November 19, 2022

From: Brian Remlinger, Professional Wetland Scientist, Alder Environmental LLC

WY State Land (Teton Village) Site 9 - Aquatic Resources and Water Quality Impact Assessment

Photo 5 – Photo Point 4. View northeast along surface water/wetland complex at Site 9 development (November 16, 2022).

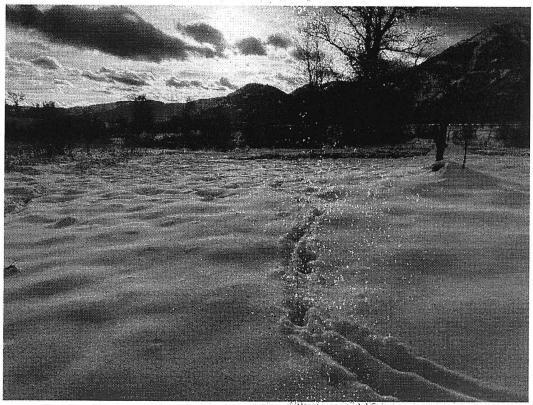
The proposed development plans at Site 9 (Teton Village Resort Construction Plans, 11/9/22) depicts a leachfield and mound near and likely within potential wetlands and surface waters. The existing contours on the plan set, a review of aerial imagery, and site observations indicate the mound from the leachfield extends into the wetland/pond complex. The leachfield infiltrators are less than 50 feet from estimated wetlands and possibly surface waters.
